**COMMONWEALTH OF KENTUCKY
BEFORE THE KENTUCKY STATE BOARD
ON ELECTRIC GENERATION AND TRANSMISSION SITING**

**ELECTRONIC APPLICATION OF HORUS)
KENTUCKY 1 LLC FOR A CERTIFICATE OF)
CONSTRUCTION FOR AN APPROXIMATELY)
69.3 MEGAWATT MERCHANT ELECTRIC)
SOLAR GENERATING FACILITY IN SIMPSON) Case No. 2020-00417
COUNTY KENTUCKY PURSUANT TO KRS)
278.700 AND 807 KAR 5:110)
)**

**HORUS KENTUCKY 1 LLC'S RESPONSES TO
SITING BOARD STAFF'S FIRST REQUEST FOR INFORMATION
TO HORUS KENTUCKY 1 LLC
(with Confidential Information in Highlight) REDACTED VERSION**

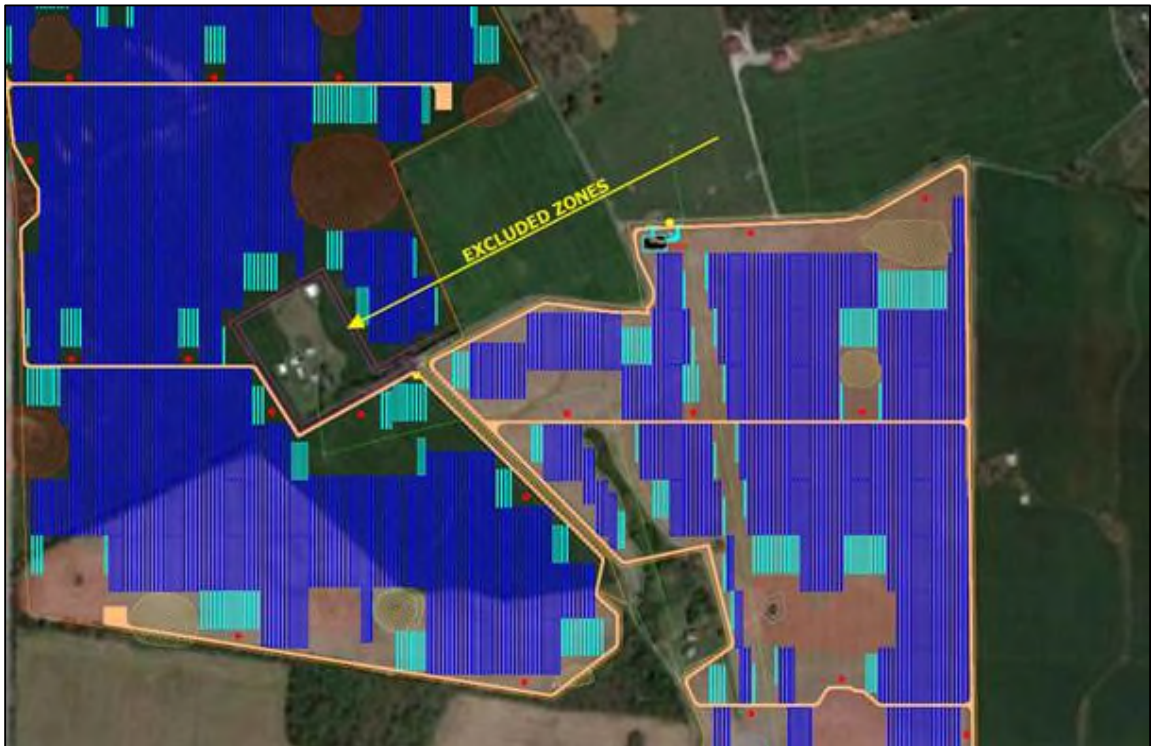
d. Identify and describe the location of the cemetery, as it is not clear on the map: [The cemetery is located in south-east of the site and it is indicated in below image:](#)

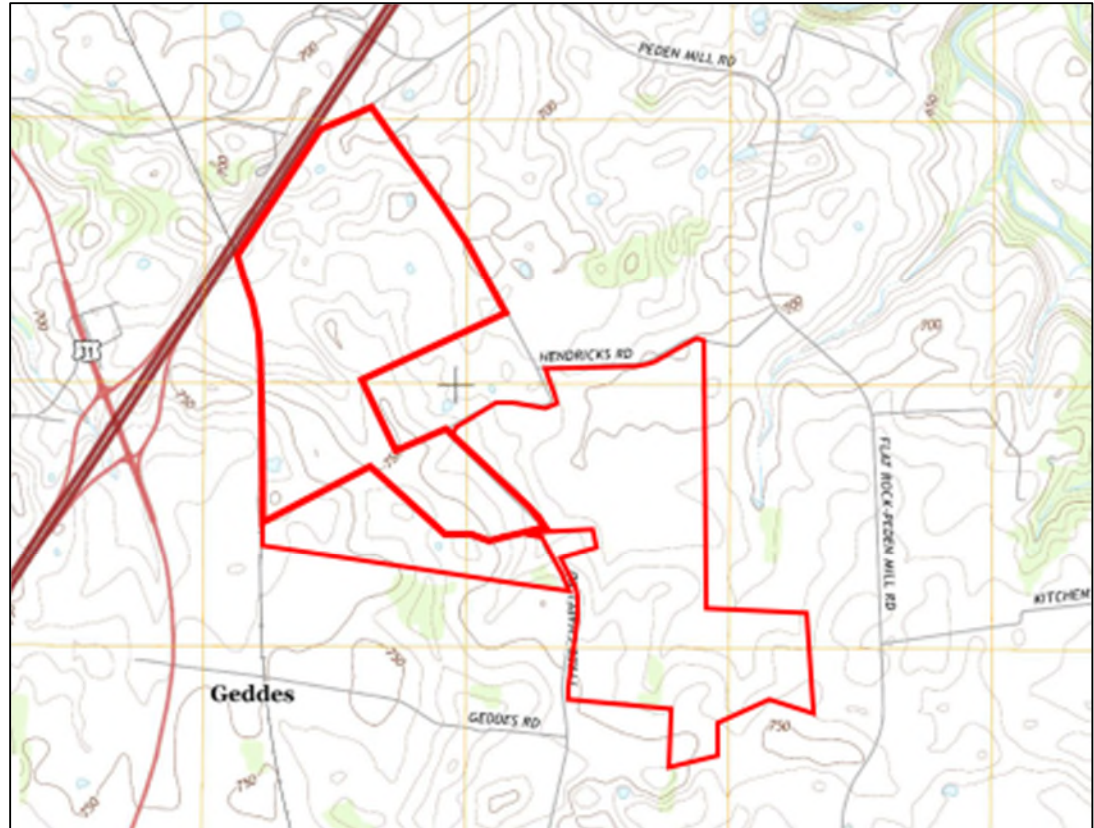
g. Explain the Excluded Zones listed in map legend, including what those zones are and their locations, which are unclear on the map: Excluded zones refer to are that includes structure/building in the center of the Project – see below image:

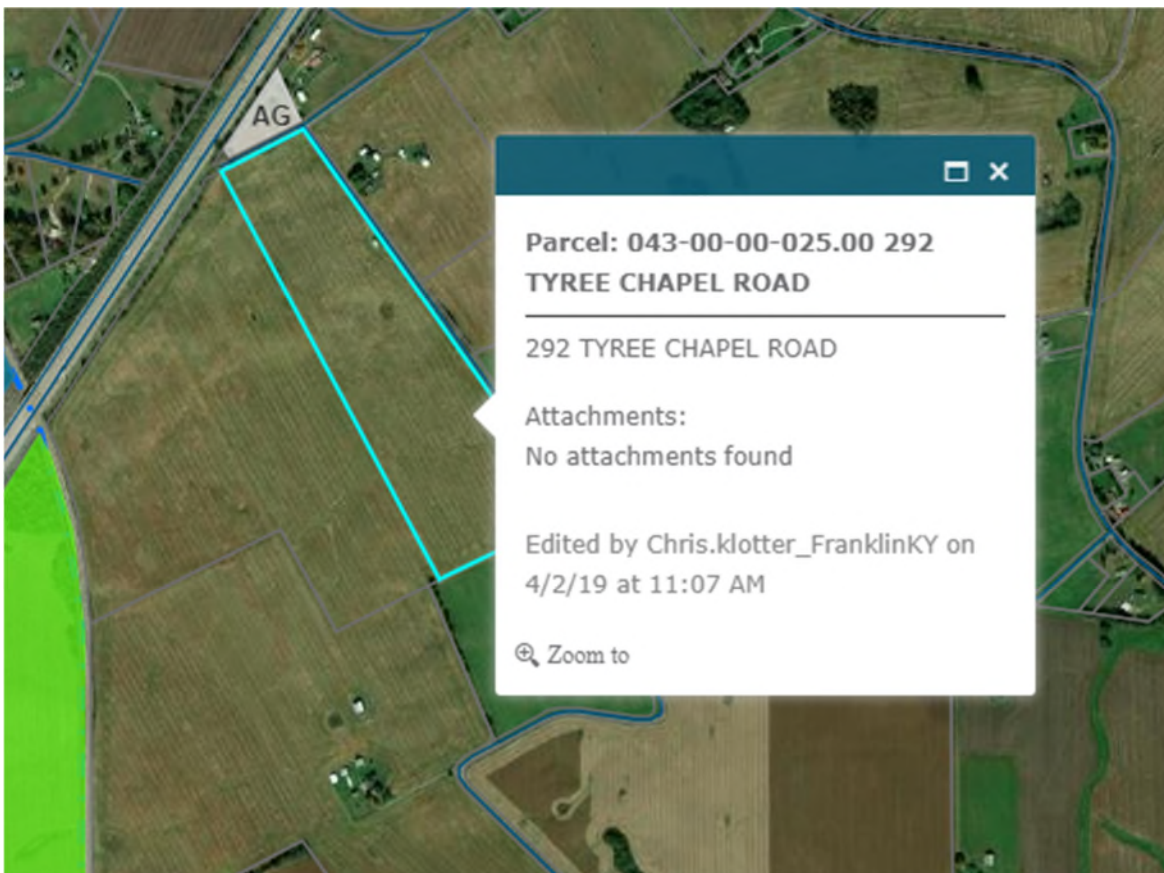
h. Identify and describe the location of the Substation, which is not clear on the map:
Marked as a yellow circle in below image.
